ENVIRONMENTAL INSPECTION REPORT

Land Use Permit MV2000P0055

June 11 and 12, 2002

Locations shown: Km 0.5, Slope 1st Creek & Slope S15

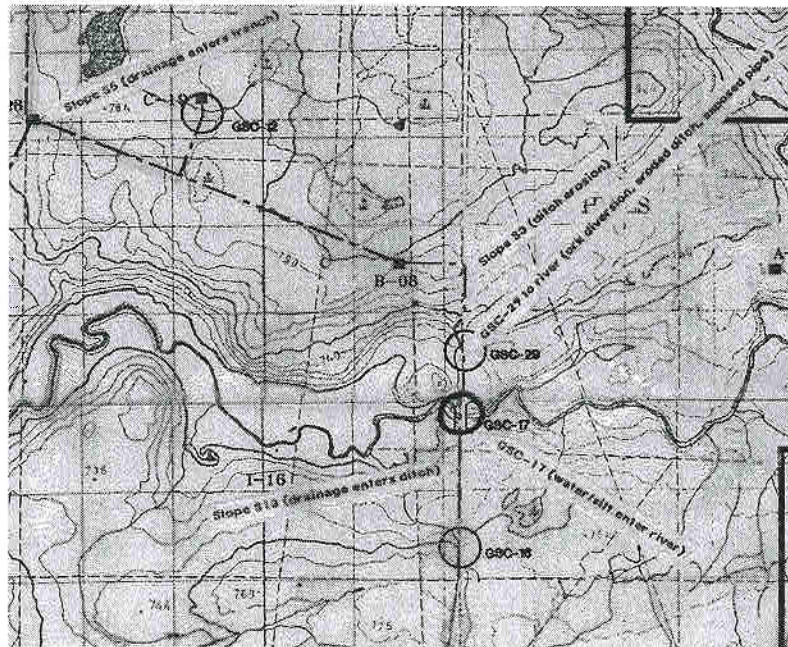
Located approximately 0.5 km from the Alberta boarder are two drainages that flow from east to west and are situated roughly 150 meters apart. Water from the northmost drainage is entering the ditch and flowing southward under the roach and empties into the south drainage. There are several washouts on the roach between the two drainages and I observed the water steadily moving southward. This situation appears to be causing an actual diversion of the natural drainage.

The creek crossing itself appears satisfactory with no signs of erosion or siltation. However the right-of-way to the south of the creek has diverted a small intermittent drainage northward along the ditch for approximately 80 meters. The water enters the r-o-w from the east then travels north for 30 meters or so before it swings west across the roach. It then travels north against the roach for approx. 50 meters where it then swings west into the bush just south of the access/r-o-w junction. Erosion is minor at this time.

There appears to be some erosion along the ditch on the long gentle slope leading to the battery site from the south. I did not inspect this site on the ground therefore have not observed the extent of erosion but it is evident from the air.

1. Correct the drainage diversion problem so that the natural drainage pattern is permanently restored and the chances of this reoccurring are eliminated.
2. Repair the eroded ditch.

1. Restore the natural drainage and ensure that the water no longer flows against the roach.
2. Repair the erosion.

1. Take steps to permanently prevent water from moving along the roach.
2. Repair the eroded ditch.

Locations shown: Slope S13 & Creek Crossing GSC-16; Cameron River Crossing GSC-17; Creek Crossing GSC-29 & the R-O-W to the Cameron River; Slope S3; Slope S5.

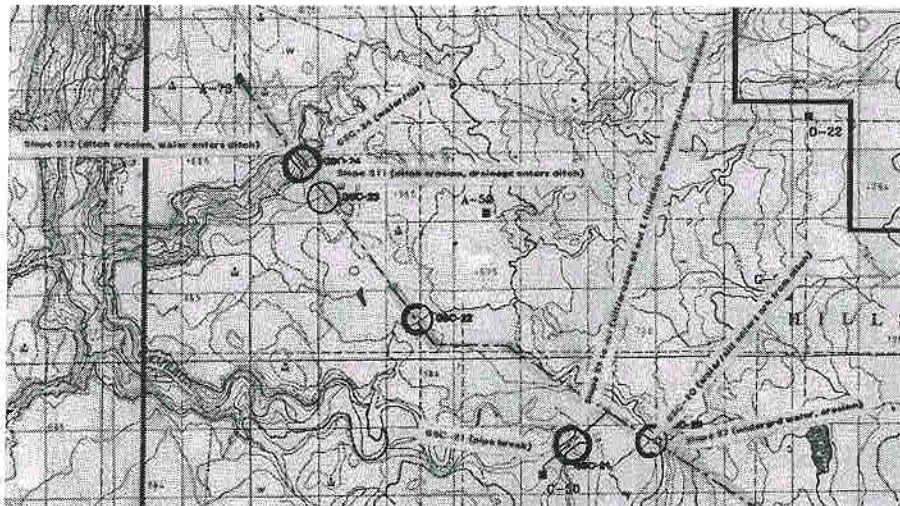
The north slope of the small hill appeared stable with no significant sign of water movement. However at the base of the hill the creek GSC-16, which flows from east to west, had entered the ditch and caused extensive erosion to the north for approx. 200 meters. Paramount has installed a temporary diversion to put the creek back on course and this looks to be working. It appears that when the creek was flowing down the ditch, the majority of the water surfaced about 200 meters down slope and moved west into the bush. The 1 km of r-o-w from this point north to the Cameron River shows signs that there was water movement under the roach for part of the way and possibly all of the way. A small quantity of water is still flowing from the roach where the pipe exits the ditch to cross the GSC-17 vehicle bridge. It appears to me that in addition to the threat from GSC-16 water is entering the ditch from the muskeg to the east and may remain a problem.

It is evident that during spring runoff, water ran northward along the east side of the roach and entered directly into the Cameron River to the east side of the vehicle bridge approach causing some erosion. It also appears that water was moving through the ditch and entering the river at the same point. There is some silt deposited along the bank which suggests that some did enter the water course. Also, water had crossed the roach via a diversion ditch approximately 30 meters south of the bridge and followed the west side of the roach toward the river. There were no signs of silt near the river on the west side of the bridge.

Creek Crossing GSC-29 is located approximately 700 meters north of the Cameron River vehicle bridge. It appears that during spring runoff, water overflowed the left bank of the creek approx. 10 meters up slope of the right-of-way causing a considerable amount of water to enter and follow the west side of the r-o-w the 700 meters to the river. This does not appear to have caused any significant erosion on the north half of the r-o-w since most of the surface consists of undisturbed organics. However some of the water was diverted into the ditch approximately 30 meters from GSC-29 via an old access road diversion ditch and this has resulted in approx. 150 meters of severely eroded ditch complete with some sections of exposed pipe.

At the top of the slope where the r-o-w turns west toward B-08, the ditch has eroded for approx. 20 meters. At first glance this situation appears minor, however upon further observation I am not so sure. Water can be seen coming out of the roach and trickling along the bottom of the ditch for the 20 meters where it disappears and no further ditch erosion on the slope is evident. I walked the entire length of S3 looking for signs of water surfacing and leaving the ditch which I finally observed coming from a diversion ditch near the bottom of the steep portion of the slope approx. 100 meters from GSC-29. I am not sure if this is the same water that enters the ditch at the top of the slope or if it enters elsewhere from under-ground. Regardless, I suggest that the slope be treated as if there has been water movement along the bottom of the ditch for it's entire length. Paramount constructed a small hand dug temporary diversion ditch near the top of the slope to prevent water from continuing down the slope.

Approximately 50 meters east of N-28 a small intermittent drainage enters the right-of-way from the north and runs directly into the ditch. It appears that during spring runoff, a considerable amount of water flowed from the drainage into the ditch and along it to the N-28 wellsite. This movement of water has resulted in erosion to the ditch for approx. 50 meters. At the time of my inspection there was still a slight quantity of water trickling into the ditch and flowing onto the wellsite.

1. Take steps to ensure that water no longer has the opportunity to leave the creek bed at the GSC-16 creek crossing and therefore can not re-enter the ditch.
2. Repair the eroded ditch.
3. Determine whether or not water is entering the ditch from the muskeg and migrating to the river. If this is the case take permanent measures to ensure that this stops.

1. Repair the surface erosion located to the east of the vehicle bridge approach.
2. Ensure that the approach to the river and the bridge approach are well seeded and a grass catch established as soon as physically possible.
3. Take steps to permanently prevent water and silt from the ditch and right-of-way from reaching the river in the future.

1. Repair the eroded ditch.
2. Take steps to prevent the creek from overflowing its bank upstream of GSC-29.
3. Remove the old diversion ditch that helped the water to enter the ditch.

1. Repair the eroded ditch.
2. Take steps to prevent the water from entering the ditch at the top end of the slope.
3. Ensure that vegetation is established as per permit conditions number 65 and 66.
4. Determine if water has been (or still is) moving along the bottom of the ditch for most of the length of the slope. If it is rectify the matter.

1. Repair the eroded ditch.
2. Take steps to permanently prevent the drainage from entering the ditch.
